ADDENDUM 01

COLLINS CENTER FOR THE ARTS ROOF REPLACEMENT University of Maine; Orono, ME

Date: April 15, 2021

CURB DETAIL

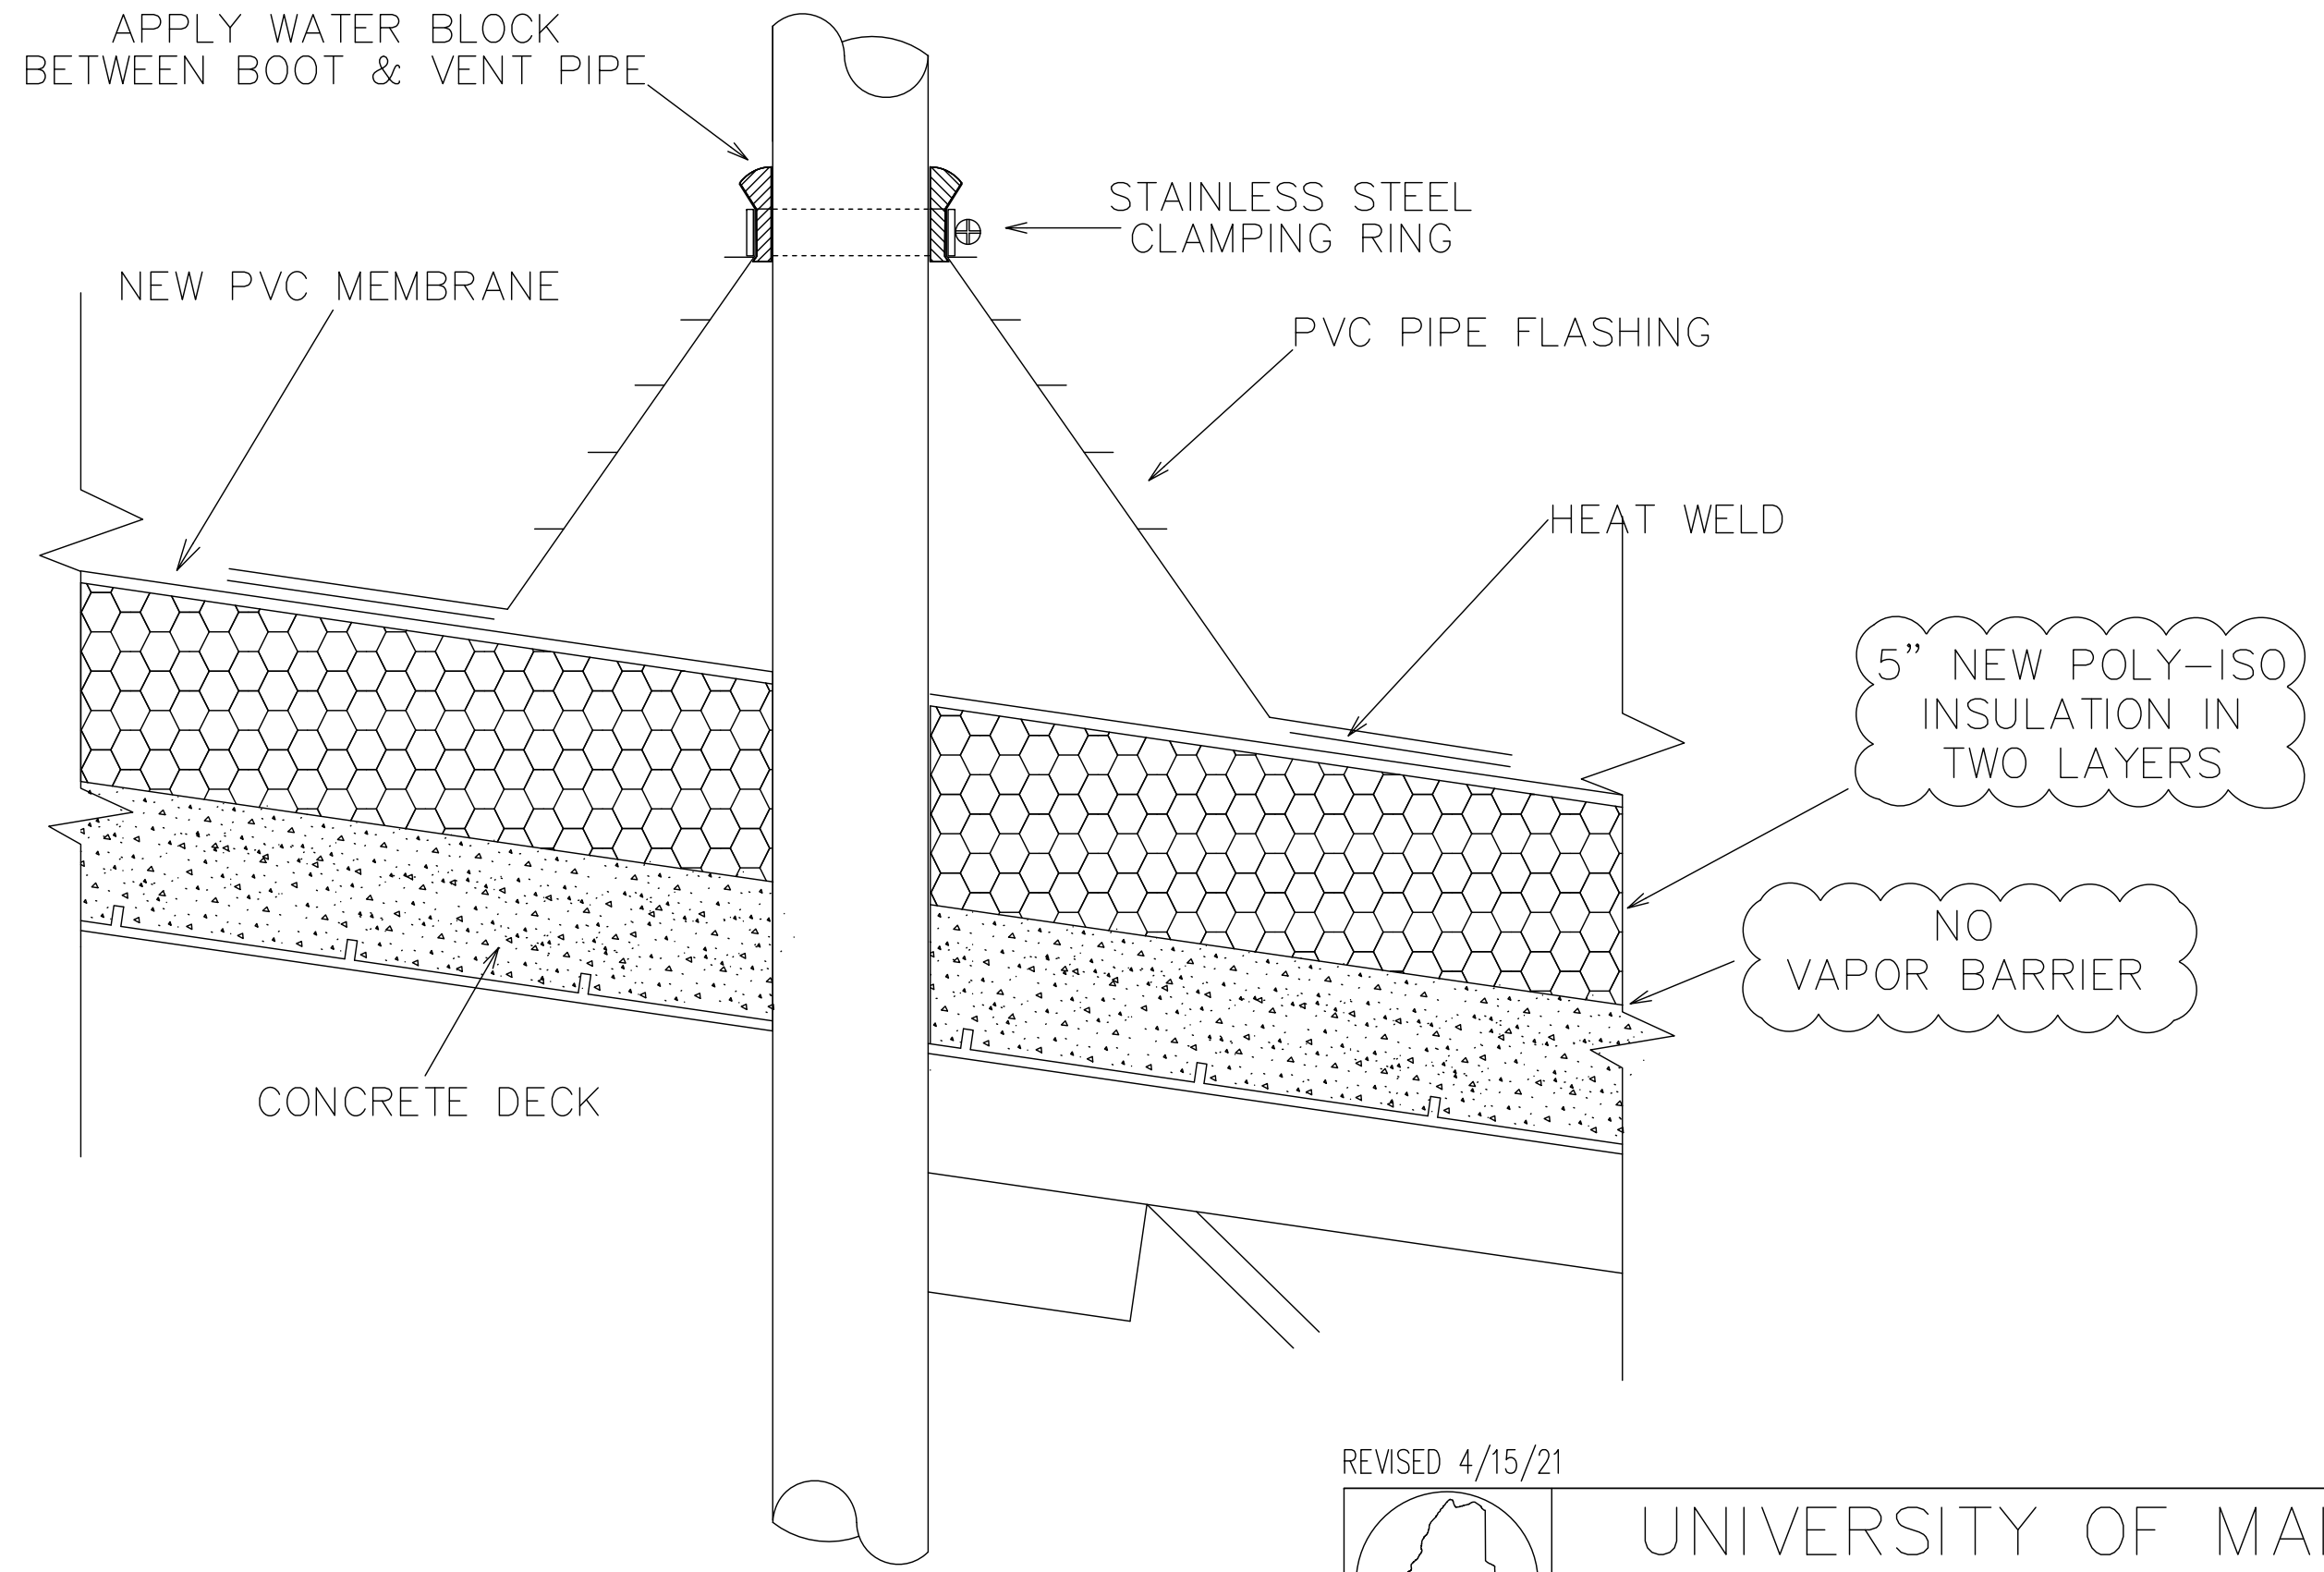
A test cut was performed; the results is an insulation thickness of 5" not 7" was found. No vapor barrier was found to exist on the concrete deck. Due to the unfinished concrete deck surface the proposed vapor barrier will not be installed and removed from the bid. The plans are modified to reflect this information.

- 1) Drawing 2, Curb Detail, DELETE and REPLACE with the attached Drawing 2 Revised, 4/15/21
- 2) Drawing 3, Vent Pipe Detail, DELETE and REPLACE with the attached Drawing 3 Revised, 4/15/21
- 3) Drawing 4, Gutter Drain Detail, DELETE and REPLACE with the attached Drawing 4 Revised, 4/15/21
- 4) Drawing 5, Snow Fence Detail, DELETE and REPLACE with the attached Drawing 5 Revised 4/15/21
- 5) Drawing 6, Perimeter Detail – Section A, DELETE and REPLACE with the attached Drawing 6 Revised, 4/15/21
- 6) Drawing 7, Ridge Detail – Section B, DELETE and REPLACE with the attached Drawing 7 Revised, 4/15/21
- 7) Drawing 8, Ridge Detail – Section C, DELETE and REPLACE with the attached Drawing 8 Revised, 4/15/21

PERIMETER DETAIL — SECTION A

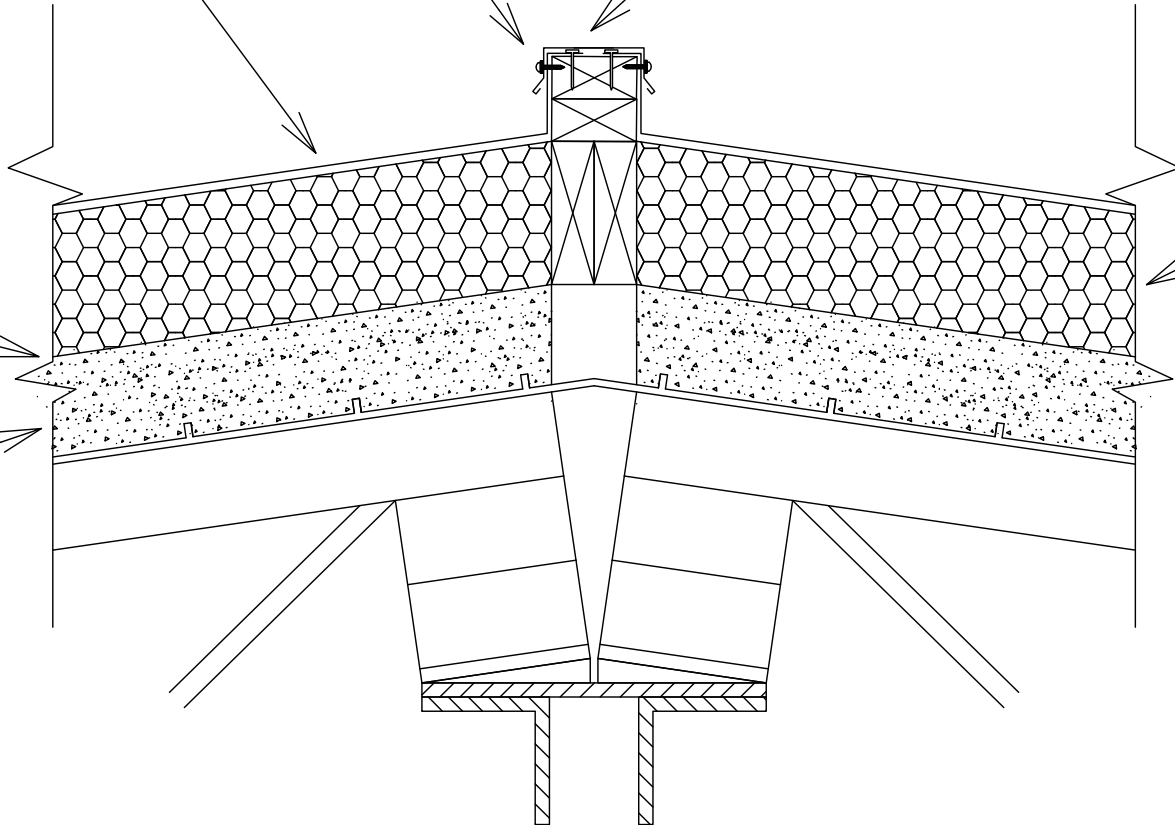
Metal perimeter flashing shall be 24 gauge steel, painted Medium Bronze. The specification is modified to reflect this information.

REPLACE RIDGE CAP W/
PAINTED METAL, MEDIUM BRONZE
IN COLOR, PER SPECIFICATIONS

5" NEW POLY-ISO
INSULATION IN
TWO LAYERS

NO
VAPOR BARRIER
